## EPC Questions – September 2, 2020

### Item 6.1 – 2300 West El Camino Real

# Draft Blueprint: Housing Growth Pattern

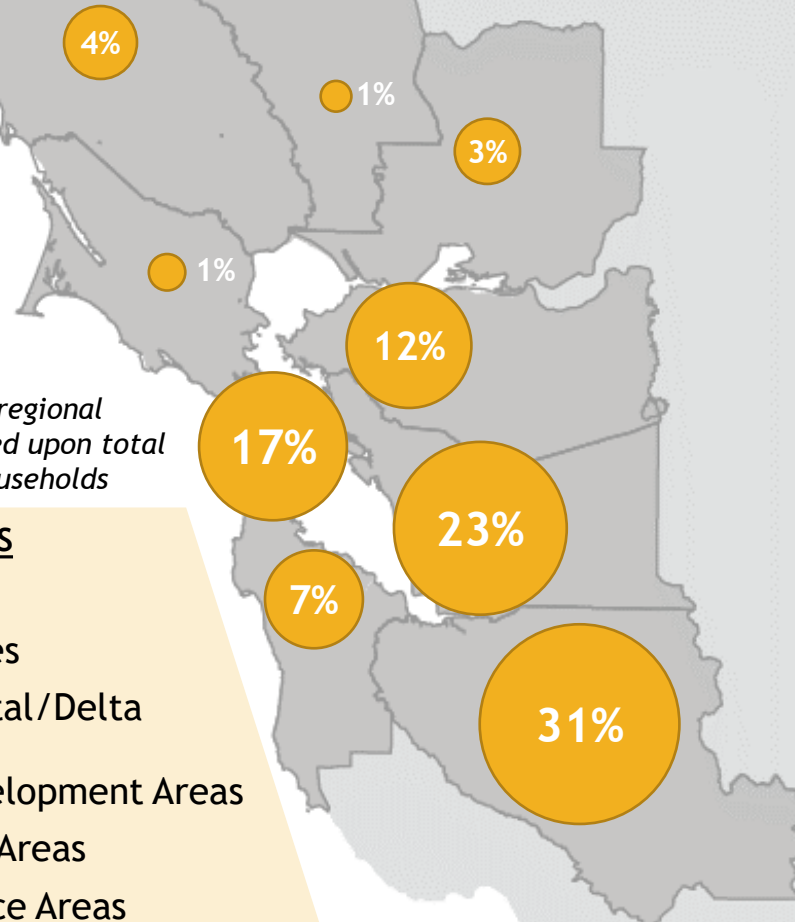
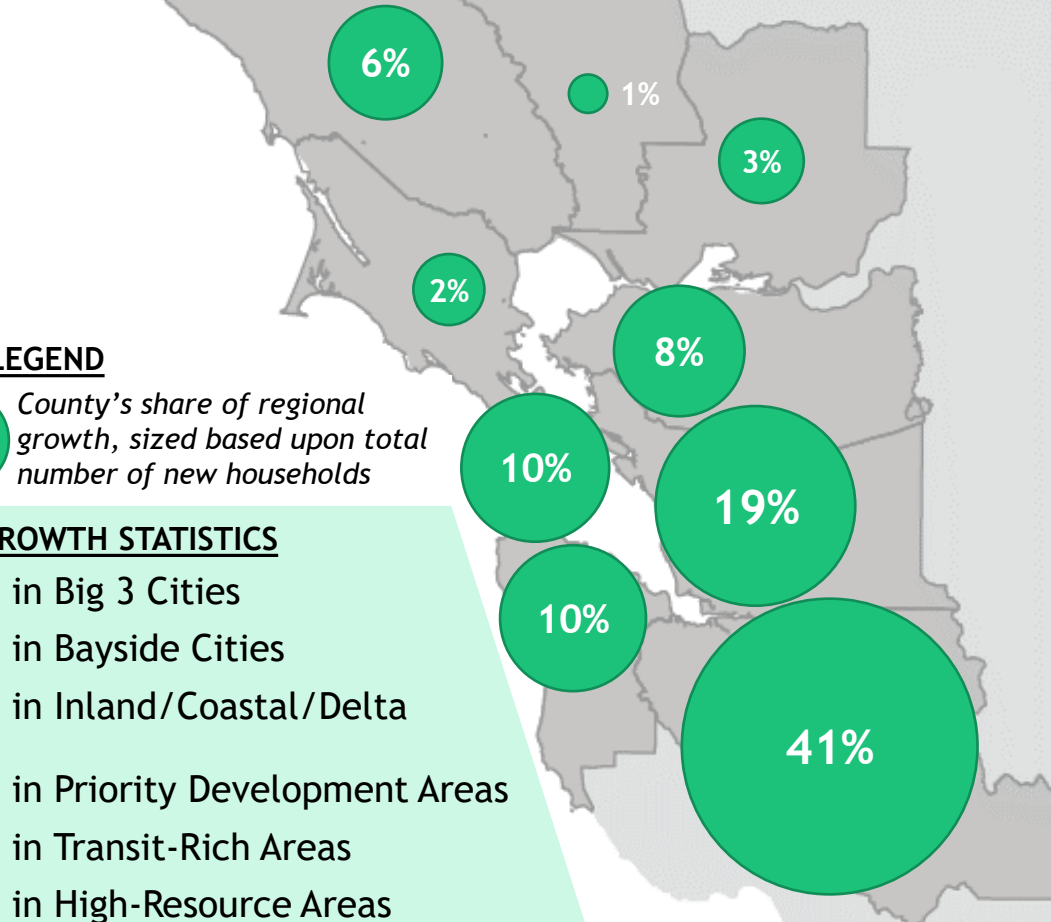
7. How much growth is allocated to San Mateo county? North Bay? East Bay

*See attached graphic for general information on growth in different areas.*
